SUBJECT: **Safety Recall 04S20: Supplement #2**
All 2002 and Certain 2003 Model Year Ford 4-Door Explorer & Mercury Mountaineer Vehicles - Liftgate Glass Hinge and Ball Stud Bracket (if applicable) Replacement

Ref: **Safety Recall 04S20: Supplement #1** dated 11/16/04
All 2002 and Certain 2003 Model Year Ford 4-Door Explorer & Mercury Mountaineer Vehicles - Liftgate Glass Hinge and Ball Stud Bracket (if applicable) Replacement

PURPOSE OF THIS SUPPLEMENT

FIGURE 3

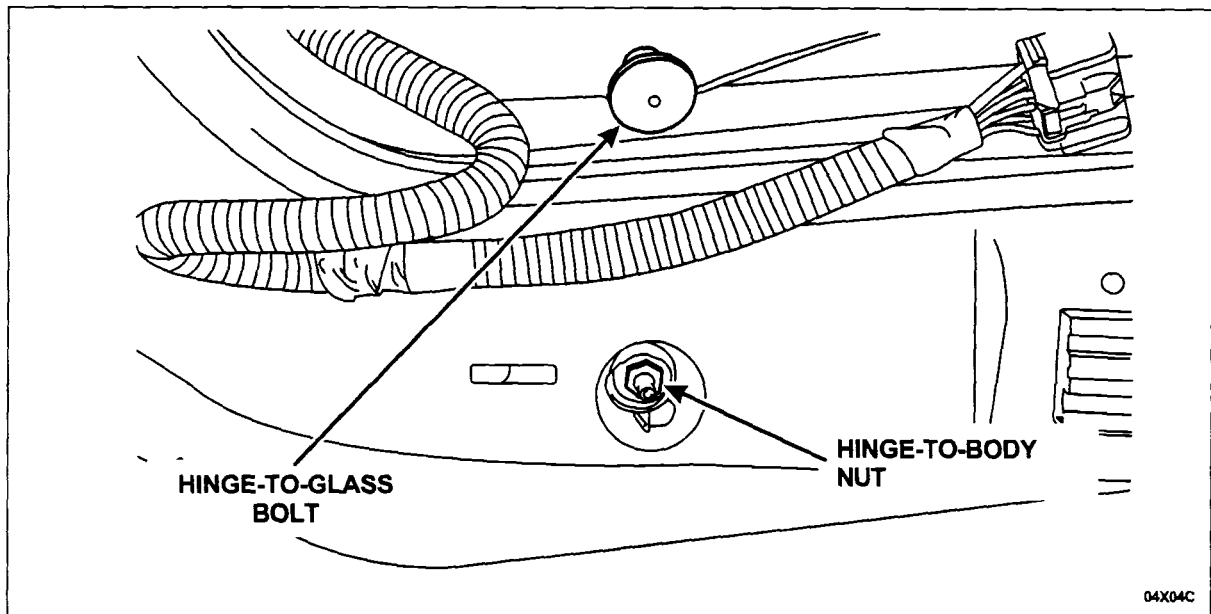
- NEW** 6. Using a magnetic socket or tool, remove one (1) liftgate glass hinge-to-body nut then the hinge-to-glass bolt and remove one (1) hinge from the vehicle. Retain the spacer from the hinge-to-glass bolts for use with the *new* bolts. See Figure 3.

- NEW**
1. Transfer the spacer from the old hinge-to-glass bolt onto the *new* bolt, then apply Threadlock 262 (Motorcraft TA-26, red high strength) to the hinge-to-glass bolt, then position the hinge onto the vehicle.
 2. Install the hinge bolt and nut **FINGER TIGHT ONLY** at this time.
 3. Tighten the hinge **BOLT FIRST** to 8 Nm (71 lb-in).
 4. Tighten the hinge **NUT SECOND** to 11 Nm (8 lb-ft or 97 lb-in).
 5. Repeat Removal Step 6 and Installation Steps 1 through 4 for the other hinge.
 6. Reposition and secure the liftgate trim panel.
 7. Close the liftgate.

THE REPLACEMENT GLASS MUST HAVE:

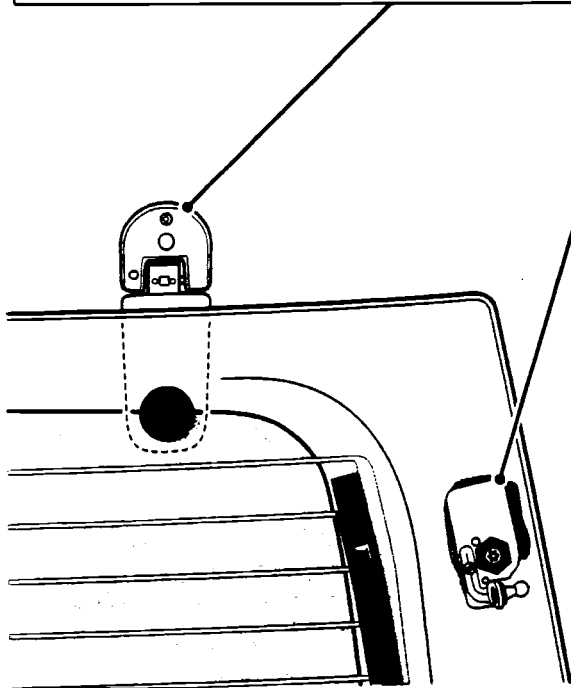
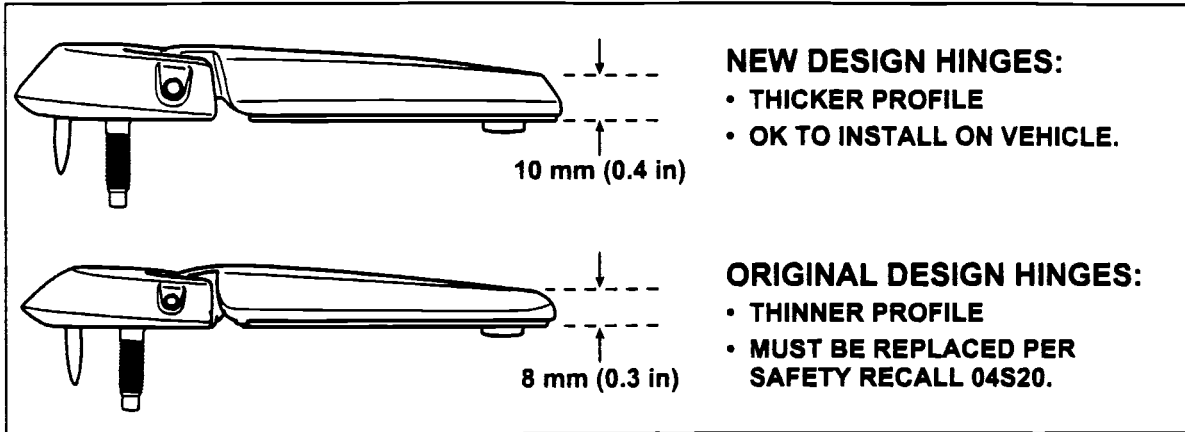
In the event that a new liftgate glass must be ordered, upon receipt, be sure that the new glass has ALL of the following before installing on the vehicle:

- *Thick design hinges*
- *Large strut brackets*
- *Hard adhesive*

This is necessary because your service glass supplier may not have provided the latest level glass assembly. Replacement glass with one of the "New" NAGS numbers shown in the chart at the end of the Q & A Section (Attachment IV) will have ALL of the above components already installed. If the replacement glass has one of the "Old" NAGS numbers, use the illustration following the chart to determine which, if any, of the above components must be updated before installing the glass.

- The new design hinges.
- Large strut brackets.
- Hard adhesive.

CAUTION: ATTEMPTING TO REMOVE A BRACKET THAT IS ATTACHED WITH THE NEW (HARD-TO-THE-TOUCH) ADHESIVE WILL LIKELY RESULT IN SHATTERING OF THE LIFTGATE GLASS.

FIGURE 1

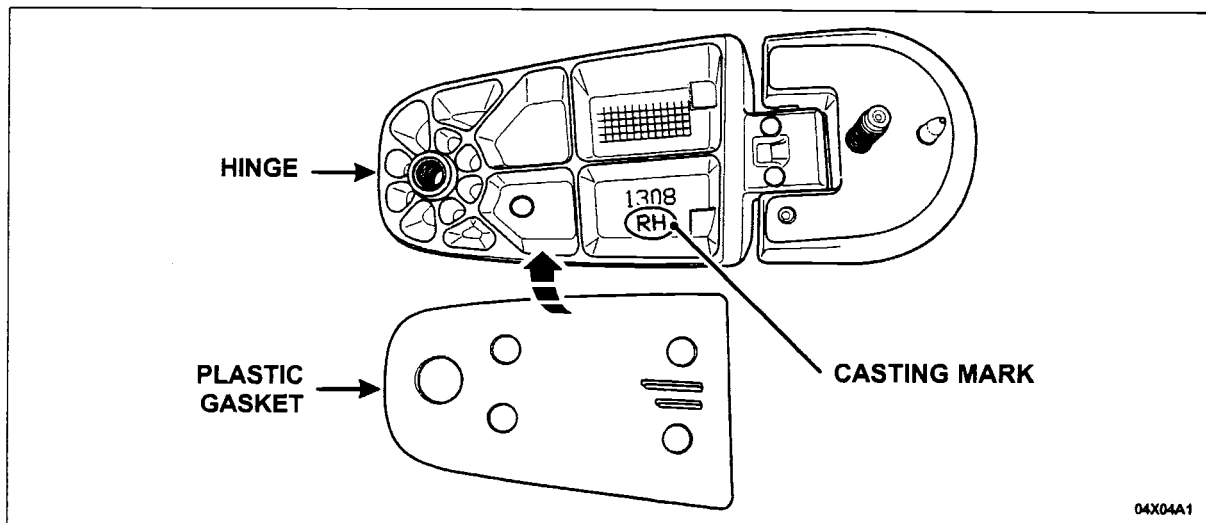
WARNING: THE *NEW* HINGES AND PLASTIC HINGE GASKETS ARE IDENTIFIED AS EITHER RIGHT-HAND OR LEFT-HAND (PASSENGER SIDE OR DRIVER SIDE). IF INSTALLED ON THE WRONG SIDE OF THE VEHICLE, THE GLASS MAY SHATTER. SEE FIGURE 1 FOR IDENTIFICATION DETAILS.

FIGURE 5

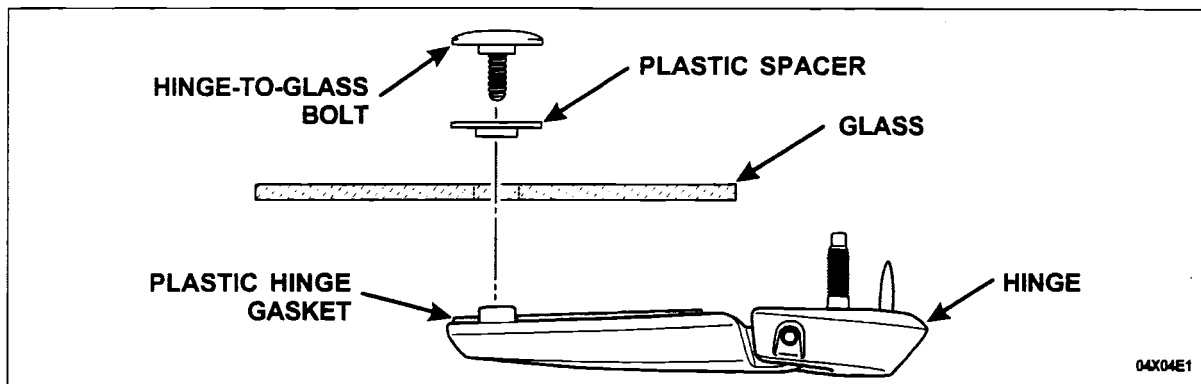
- *Advise dealers of revisions to the Technical Instructions for Hinge Replacement. The hinge repair procedure did not clearly specify that the hinge-to-glass bolt spacer needs to be reused. Failure to reuse the spacer may result in the glass shattering upon bolt installation.*
- *Advise dealers of parts availability and ordering information (Attachment II).*
- *Provide a simple means for determining if replacement glass has updated components (Attachment IV).*
- *Advise dealers of revised Questions and Answers (Attachment IV).*
- *Provide informational copy of customer follow-up postcard (Attachment V).*

WARNING: THE PLASTIC SPACER LOCATED UNDER THE ORIGINAL HINGE-TO-GLASS BOLT MUST BE TRANSFERRED TO THE *NEW* BOLT. FAILURE TO INSTALL THIS SPACER WILL RESULT IN SHATTERING THE GLASS UPON BOLT INSTALLATION. SEE FIGURE 5.
